Official Transcript of Proceedings
NUCLEAR REGULATORY COMMISSION

Title: Advisory Committee on Reactor Safeguards
 NuScale Subcommittee

Date: Thursday, May 16, 2019

NuSCALE SUBCOMMITTEE

RAI 410-9310, Question 03.09.02-70

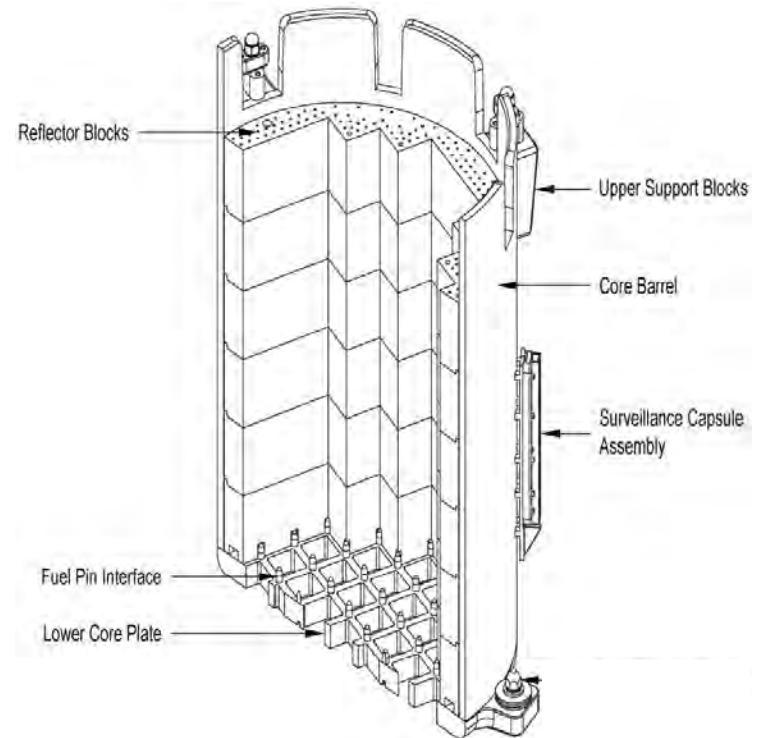
- **Concern:** The core barrel and reflector are separated by a thin fluid gap. The fluid gap was not considered in the analysis.
- With presence of fluid gap, frequencies of the core barrel and reflector are lower due to added mass effect of the fluid gap.
- **Applicant response:** The lower RVI submodel was updated to capture the added mass effect of the fluid gap using the ANSYS Fourier node method.
- The staff finds the response acceptable and will review the updated lower RVI submodel in TR-0916-51502 Revision 2
- RAI 9310 Question 03.09.02-70 is resolved.

General Testing Concerns

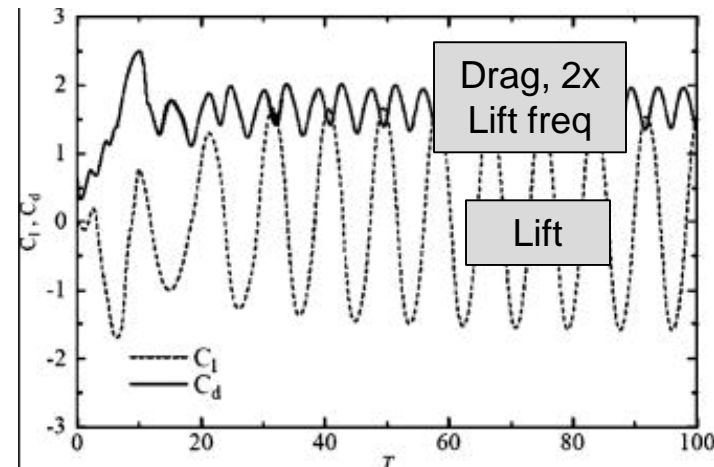
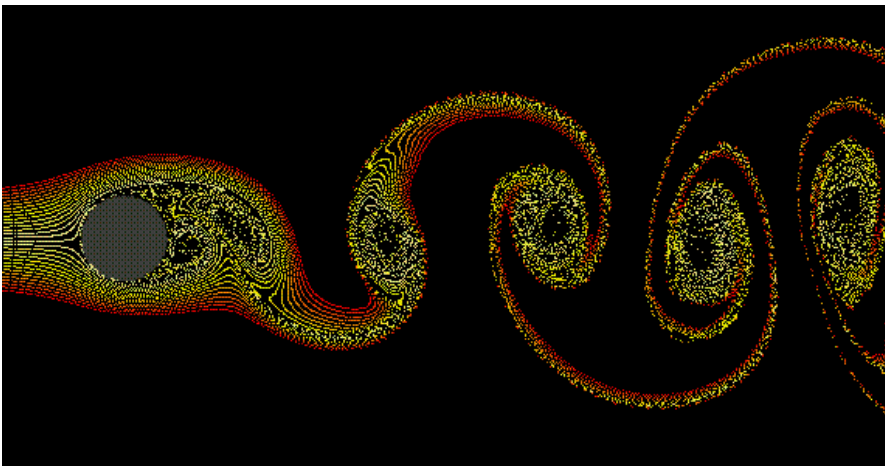
- Less benchmarking and testing than usual for a DCD
 - Unique new design with no operating history or similar predecessor
 - Pre-operational FIV testing infeasible due to natural circulation design
 - However, turbulent buffeting benchmarking unnecessary due to very low flow rates
- Staff proposed the following for reasonable assurance against significant FIV
 - Preliminary/validation testing focuses on key FIV mechanisms with low margins of safety and high uncertainty
 - Initial startup testing will focus on identifying any unexpectedly high FIV
 - Not intended for specific mechanisms or benchmarking

CRDS and ICIGT VS (OI 03.09.02-03)

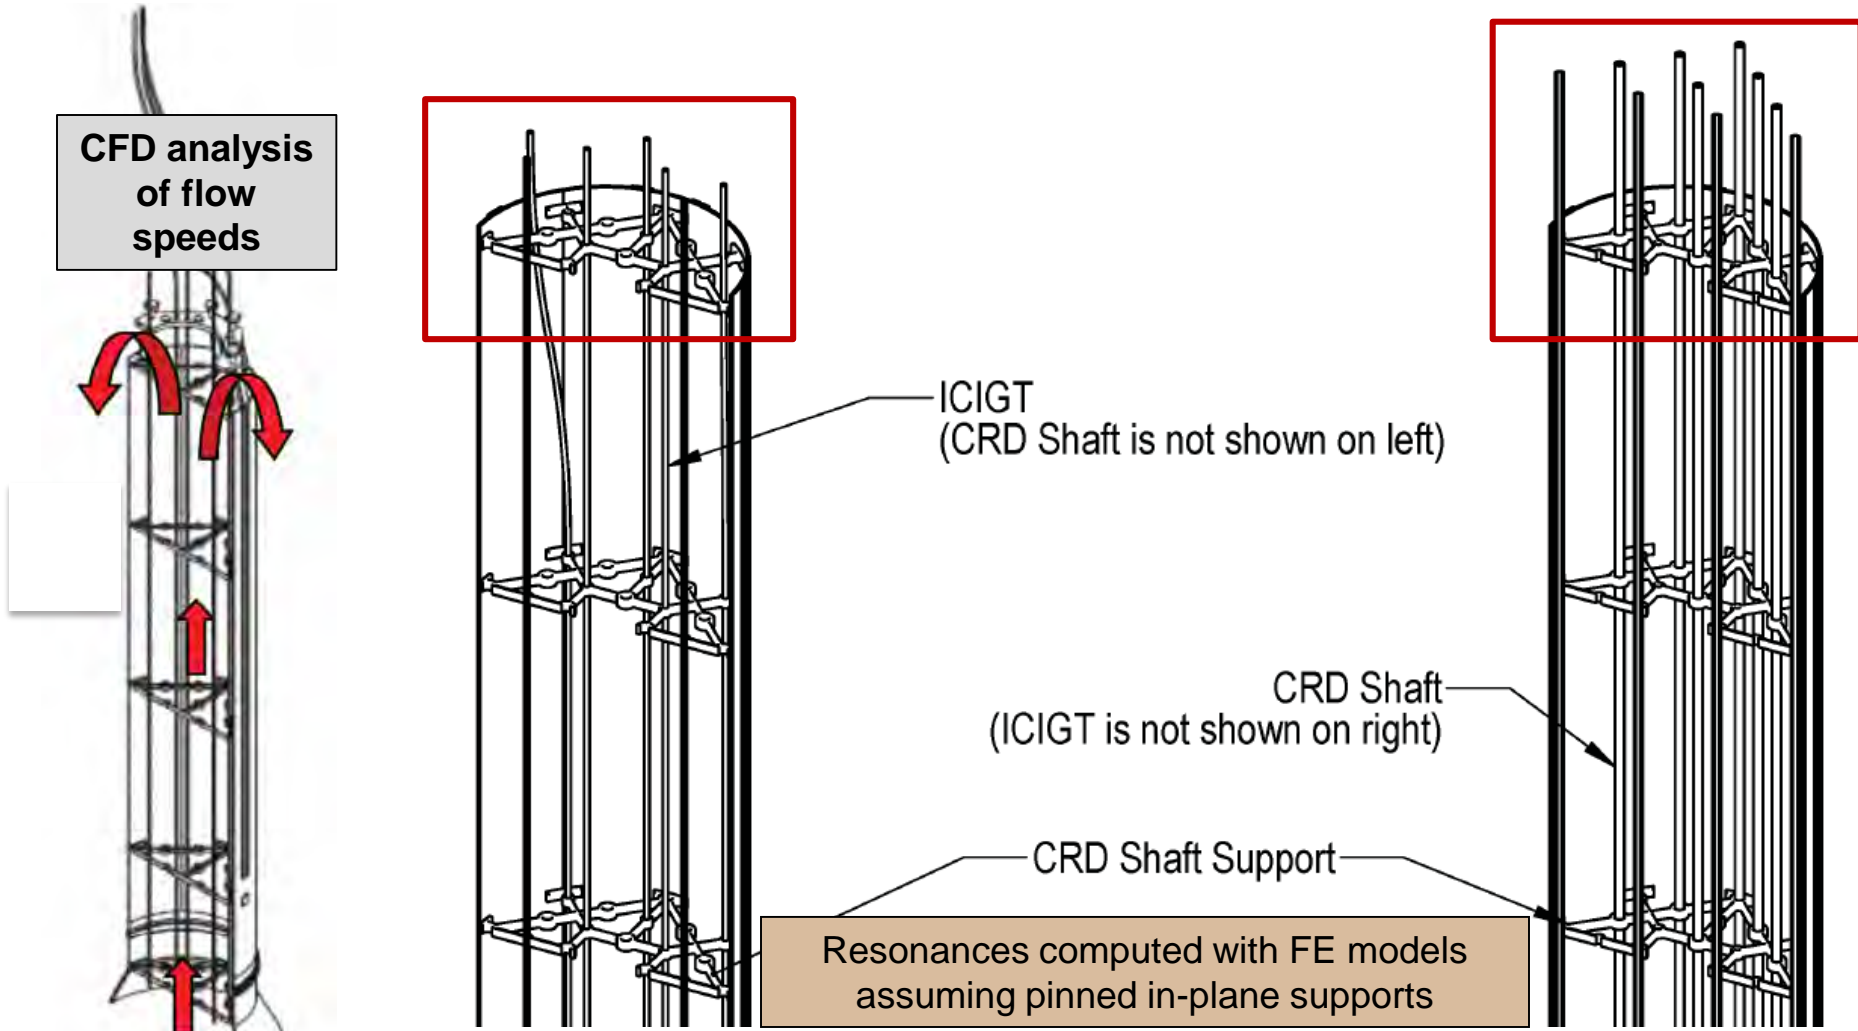
Top sections of ICIGT and CRD Shafts exposed to cross flow; vortex shedding/lock-in is possible

HCSG Lower Tubing VS (OI 03.09.02-01)

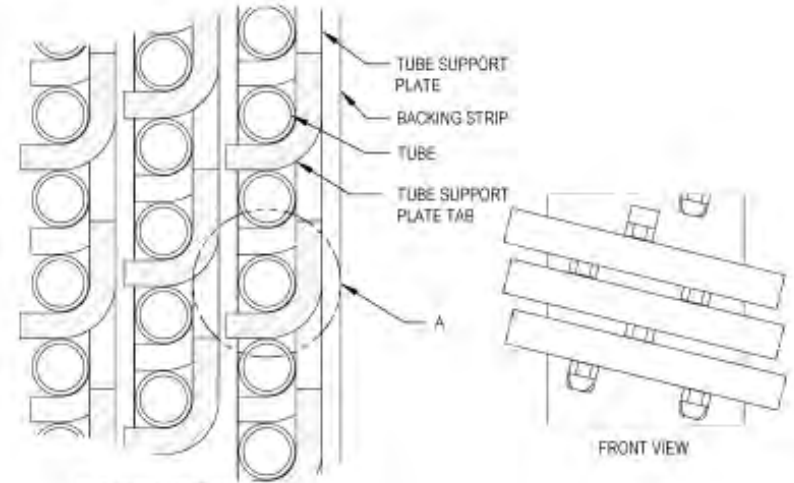
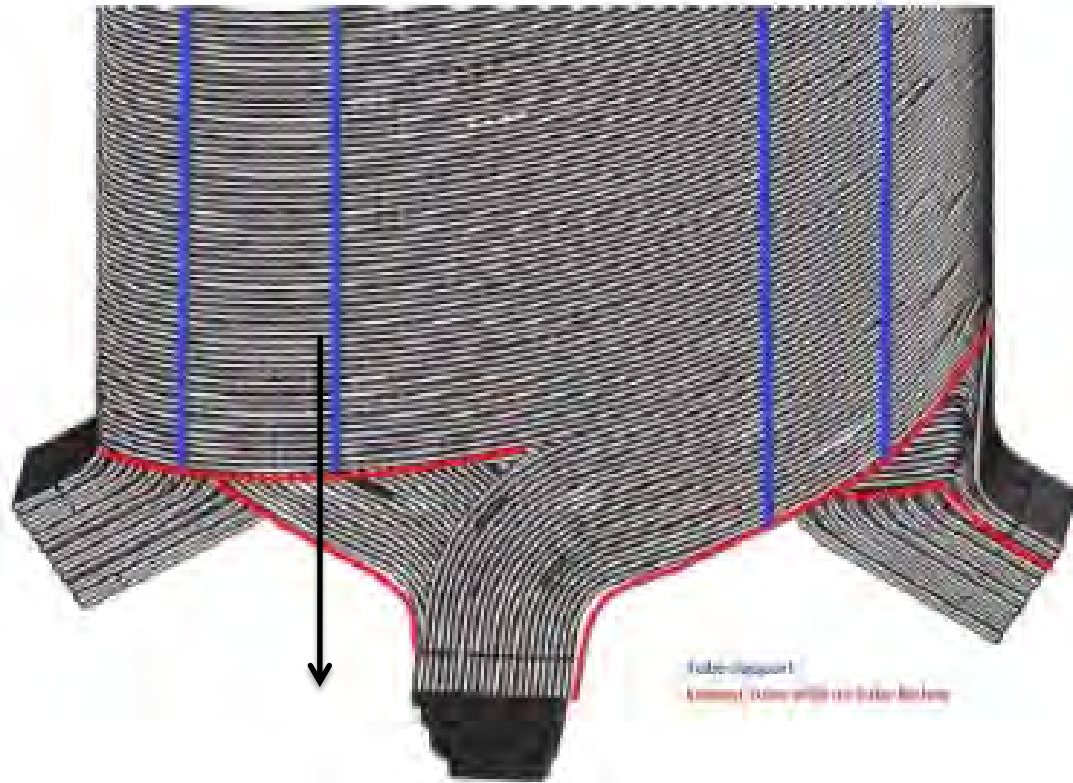
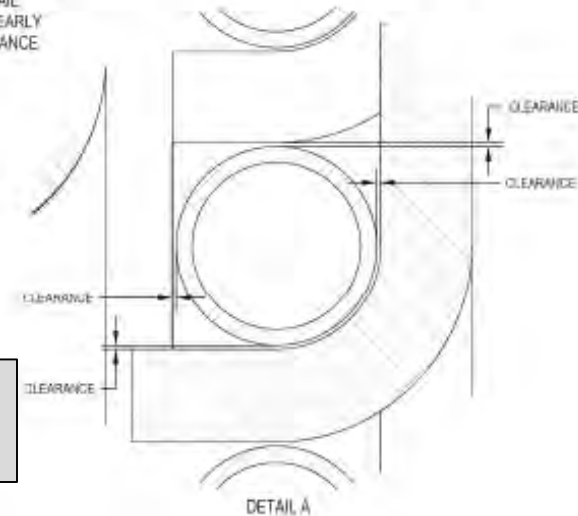
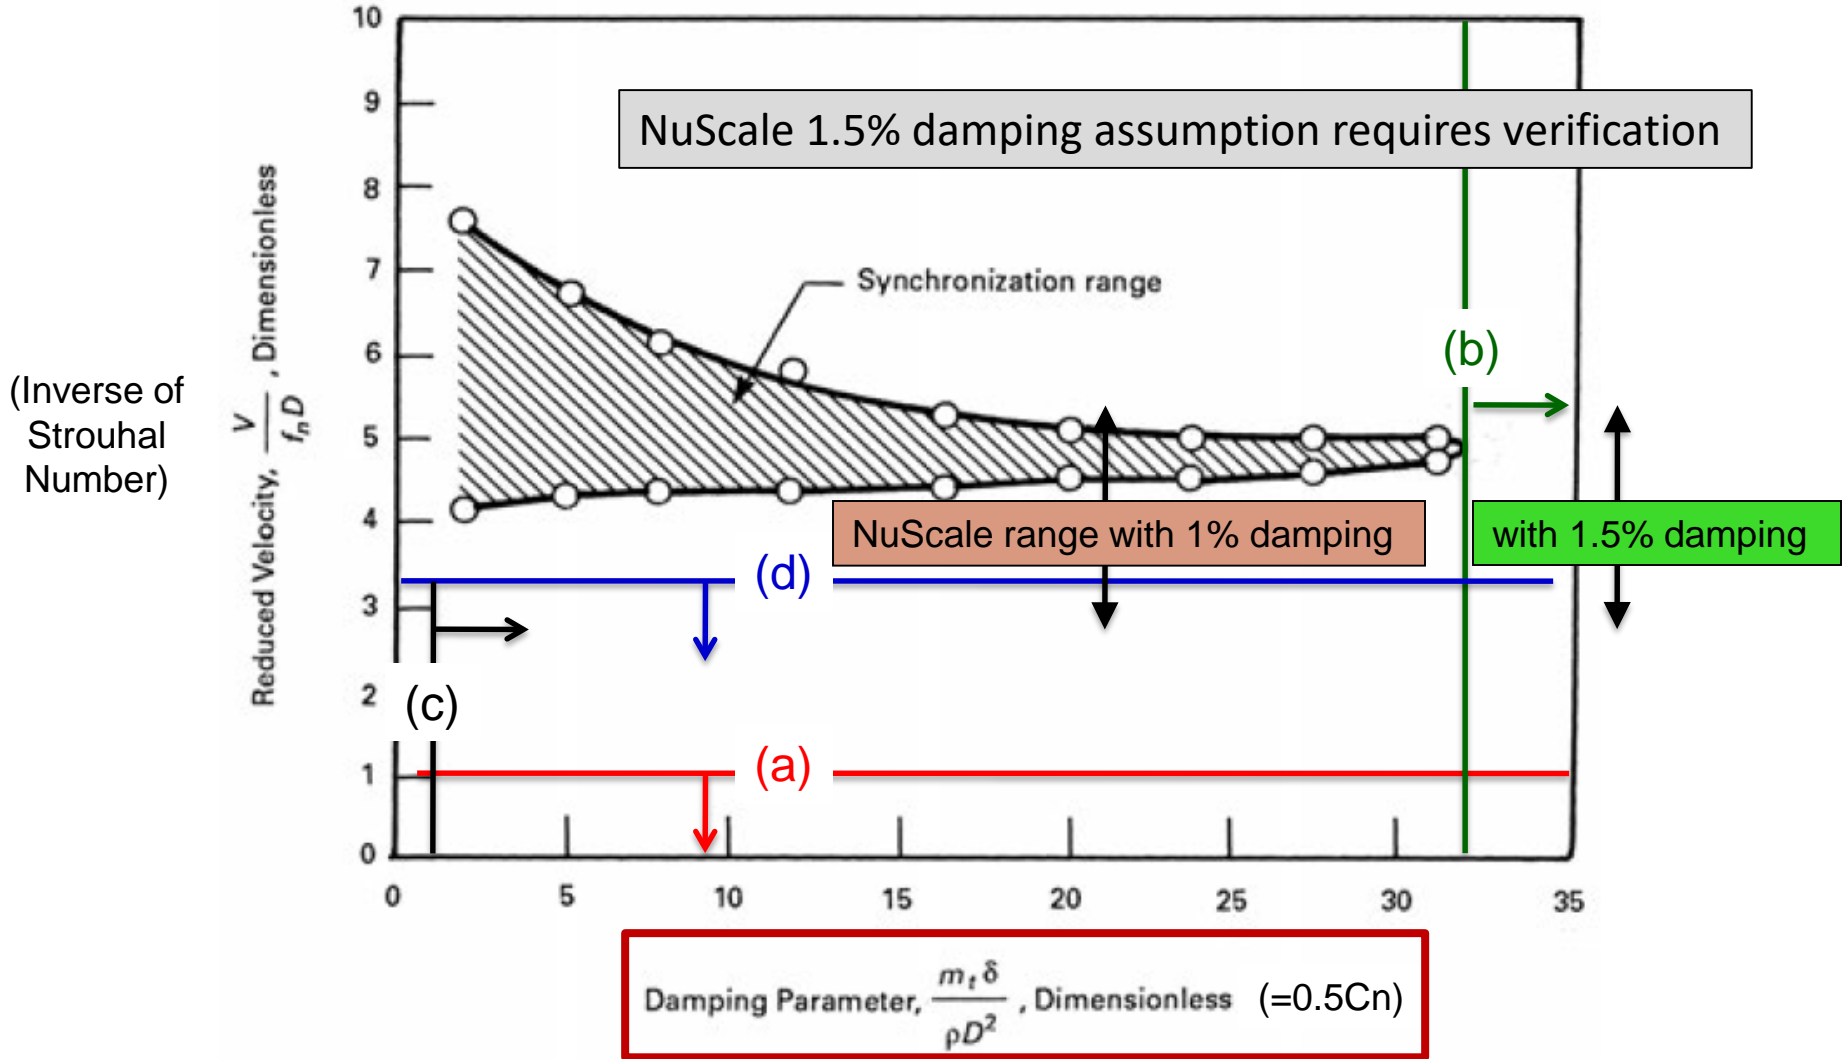
Bottom SG tubes exposed to cross flow, vortex shedding/lock-in is possible

0.009" nominal clearances specified, operating clearances unknown
 NuScale assumes fully active supports for FIV analyses

HCSG Fluid-Elastic Instability

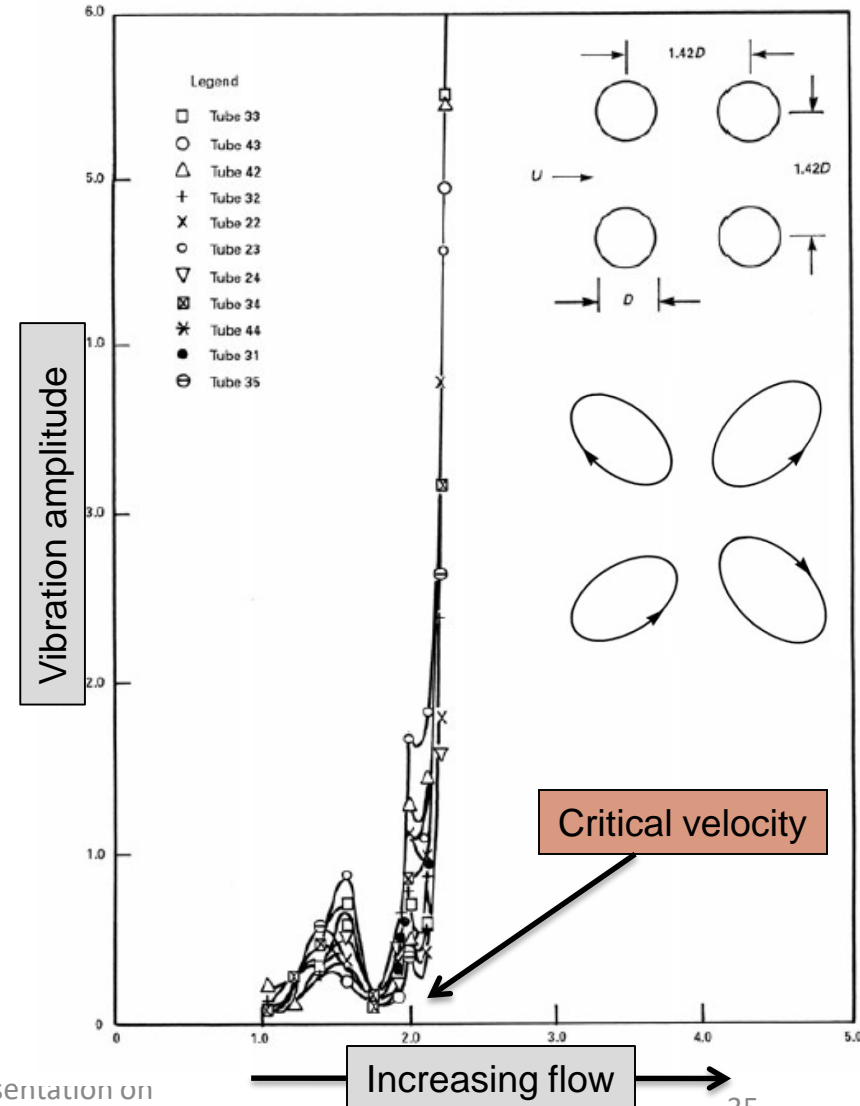
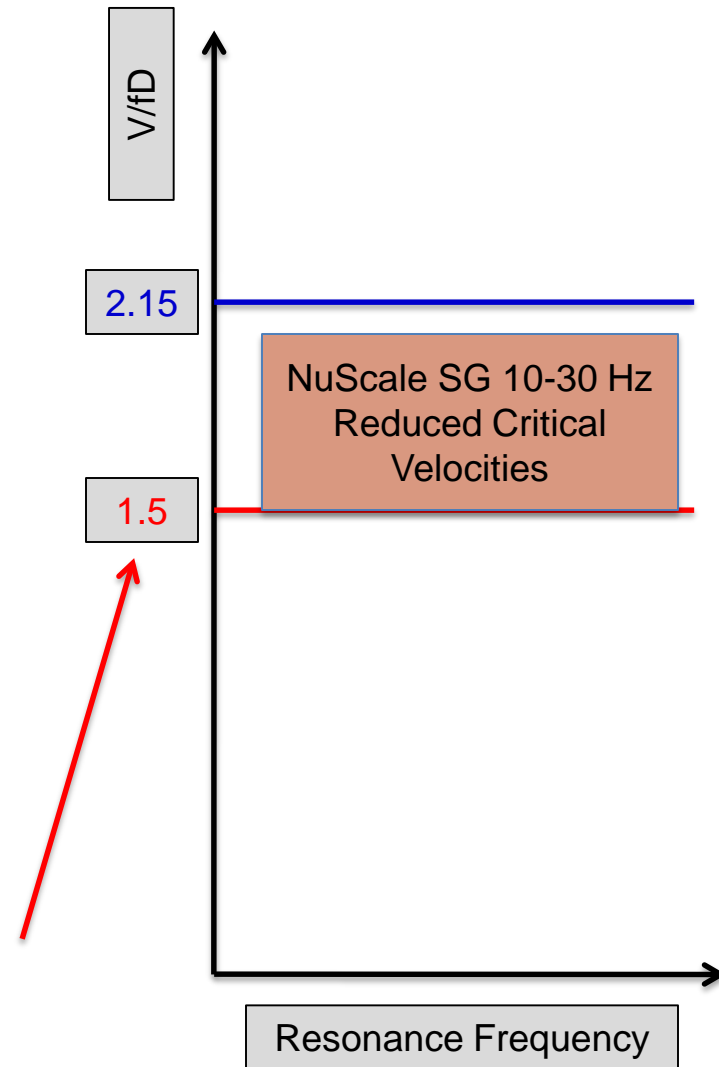
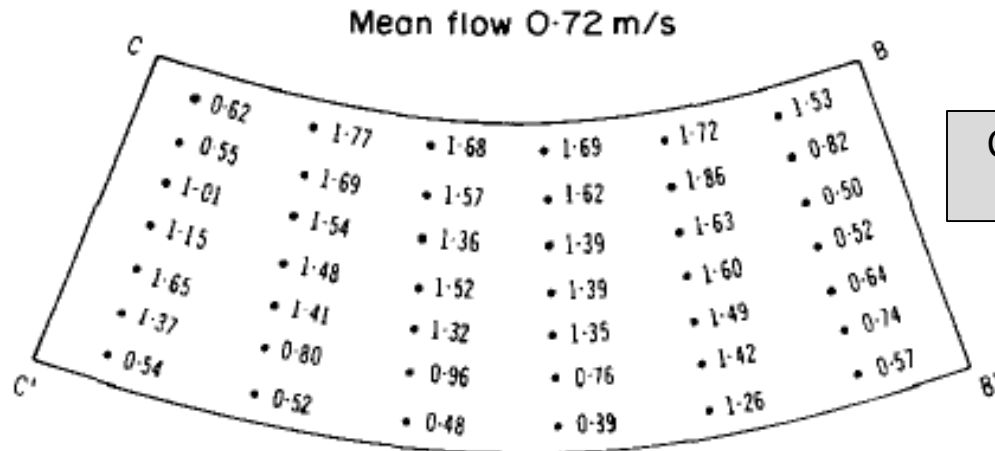
- Occurs when:
 - Vortex field around multiple tubes couples constructively with structural motion
 - Flow velocity exceeds critical value
 - Extremely high displacements, usually limited by contact with nearby tubes
- Estimate reduced critical velocity via empirical fit with two constants C and a to measured data for different tube array types
 - Critical velocity depends on mass-damping

- NuScale computes critical velocities for first 50 modes of HCSG tubes
 - Estimates resonance frequencies and mass-damping of each mode
 - Considers Connors (straight tube array) and Chen, 1983 (helical array) empirical constants
- Critical velocities are compared to gap velocities estimated from CFD bulk flow and blockage of tubes
- HCSG reduced critical velocities (V/fD) with fully active supports range from $\sim 1.5 - 2$ for modes with resonance frequencies less than 30 Hz
 - Connors reduced critical velocity is 2.15, so small margin exists
 - Actual reduced critical velocity should be around 1.5 per Chen; tubes may experience onset of FEI between 10 and 30 Hz

- If any supports are inactive, longer sections means lower resonance frequencies, so more modes will be susceptible to FEI
- Non-conservatisms:
 - SG tube damping is assumed to be 1.5%, greater than RG 1.20 specified 1%
 - No mesh convergence studies, biasing resonance frequencies higher
 - Lower (non-conservative) average velocity through region used for analyses with partially inactive supports
 - Actual flow velocities will vary throughout the annulus; regional velocities may be higher
